SUBJECT: RIVER BEND STATION, UNIT 1 - ISSUANCE OF AMENDMENT RE:
CORRECTION OF A NON-CONSERVATIVE TECHNICAL SPECIFICATION
FOR PRESSURE-TEMPERATURE LIMITS (EPID L-2018-LLA-0083)

Amendment No. 195
Renewed License No. NPF-47

SAFETY EVALUATION BY THE OFFICE OF NUCLEAR REACTOR REGULATION

Figure 3.4.11-1 (page 1 of 1)
Minimum Temperature Required vs. RCS Pressure
Without Uncertainty for Instrumentation Error

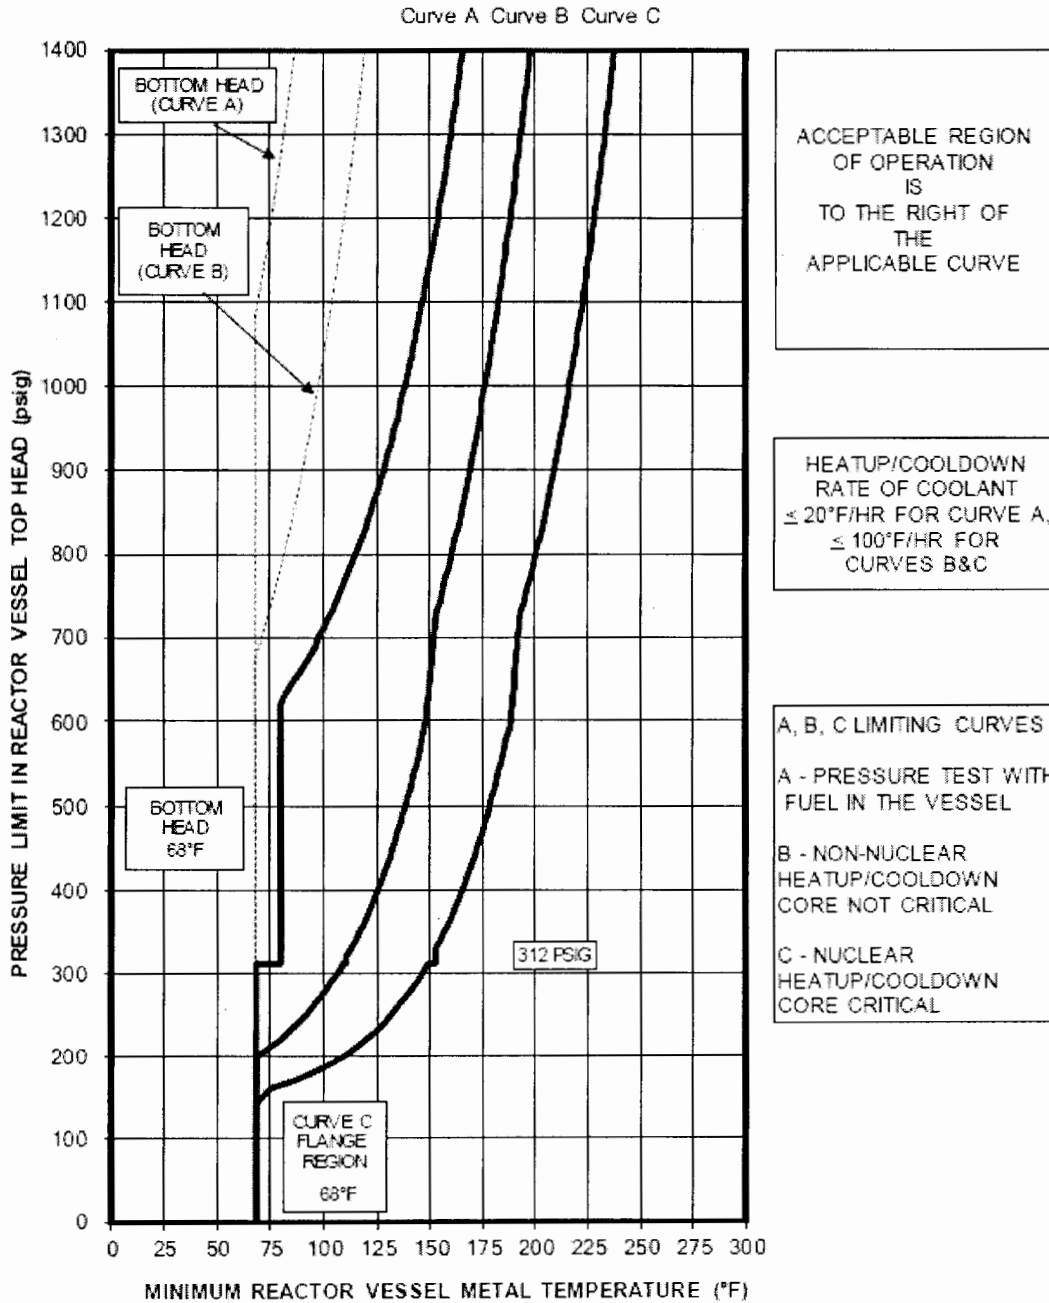
The amendment revises the River Bend TS Figure 3.4.11-1, "Minimum Temperature Required vs. RCS [Reactor Coolant System] Pressure," for reactor heatup, cooldown, and critical operations as well as for inservice leak tests and hydrostatic tests. This change replaces the non-conservative curve, which is for 32 Effective Full Power Years (EFPY) with a new curve that is for 54 EFPY.

In the LAR dated April 2, 2018, Entergy identified that the existing P-T limits for Curves B and C at 32 EFPY were determined to be non-conservative based on a GEH assessment. The licensee stated that the P-T limit curves for 32 EFPY approved in License Amendment No. 120, inadvertently omitted the effects of the **[[** discontinuity on the stress intensity factors for assessed RPV beltline components in the year 2000 P-T limits submittal. **]]** The licensee stated that the updated P-T limit curves for 54 EFPY, submitted in the application, propose to resolve the non-conservatism. The licensee took this action in accordance with the NRC staff position in NRC Administrative Letter (AL) 98-10, "Dispositioning of Technical Specifications Insufficient to Assure Plant Safety" (Reference 9). This AL provides the NRC staff position on the discovery of non-conservative TS requirements in the licensing basis, and the corrective actions that may be applied by a licensee. The long term corrective action to be taken by the licensee upon the discovery of a non-conservative or non-conforming TS requirement is to submit an LAR to the NRC.

The NRC staff observed that the revision to TS Figure 3.4.11-1 included a statement that the P-T limit curves were developed "**[[]]**." The NRC staff requested the licensee to account for **[[]]** for 54 EFPY.

However, the NRC staff observed that by adding new P-T limit curves for the RPV bottom head into TS Figure 3.4.11-1, the specific SR statements in TS 3.4.11.1 could become unclear because the TS SR section does not define how or when the licensee should perform specific types of P-T monitoring activities against the new P-T limit curves for the bottom head (i.e., those for Service A and B loading conditions) versus those for the RPV beltline region under Service A and B loading conditions.

During its review, the NRC staff could not verify that the proposed P-T limit curves for the RPV beltline region under Service B and C loading conditions would meet the requirement in 10 CFR Part 50, Appendix G, for incorporating appropriate conservatism in P-T limit calculations. Specifically, the NRC staff noted the plant-specific basis for assessing the []

In the letter dated October 4, 2018 (Reference 2), the licensee stated that the treatment of **[[]]** will be addressed in an update of River Bend Procedure STP-050-0700, "RCS Pressure/Temperature Limits Verification," which will be tracked through an item in the licensee's Paperless Condition Reporting System (PCRS). The NRC staff finds this approach to be an acceptable alternative regarding the treatment of **[[]]** for 54 EFPY.

In the letter dated October 4, 2018, the licensee stated that River Bend Procedure STP-050-0700, is used to meet the TS SR requirements associated with the P-T limit curves in TS Figure 3.4.11-1. The licensee clarified that the current version of the procedure only includes criteria for monitoring RCS temperatures in the vicinity of the beltline region of the RPV. However, the licensee stated that, with the implementation of P-T limit curves for both the beltline and bottom head regions of the RPV, the procedure will be updated to require RPV beltline and bottom head temperature monitoring be performed in relation to the corresponding P-T limit curve for the RPV location in the updated TS figure. The licensee stated that the changes to the procedures will be tracked through the site-specific PCRS. The NRC staff finds that since the procedural changes will be tracked by the PCRS and will be subject to applicable criteria in the licensee's 10 CFR Part 50, Appendix B, quality assurance program, these SR monitoring criteria do not need to be accounted for through a proposed change to the provisions in TS SR Section 3.4.11.1. The NRC staff also finds that the current version of TS SR Section 3.4.11.1 is adequate without any need to amend the existing TS SR section by the licensee.

By letter dated October 4, 2018 (Reference 2), the licensee stated that use of an [] [] is warranted for the P-T limits assessment of the [] [] because it is based on the methods in WRC Bulletin No. 175. The methods contained

The NRC staff determined that the licensee's response provided sufficient justification for applying [] [] to the P-T limit thermal stress evaluation of the [] [] because they are based on the NRC staff-endorsed methodology in WRC Bulletin No. 175. The NRC staff also determined that the P-T limit curves proposed for the RPV beltline region under Service B and C loading conditions are acceptable because they meet the requirements in 10 CFR Part 50, Appendix G, and the safety margin requirements in ASME Code Section XI, Appendix G, including those specified in the ASME appendix for RPV nozzle appurtenance assessments. Based on this review, the NRC staff finds that the licensee may implement the proposed P-T limit curves for 54 EFPY that apply to the RPV beltline region under Service B and C loading conditions, with a maximum allowable 100 °F/hr restriction on RCS temperature rate changes associated with these types of operations.
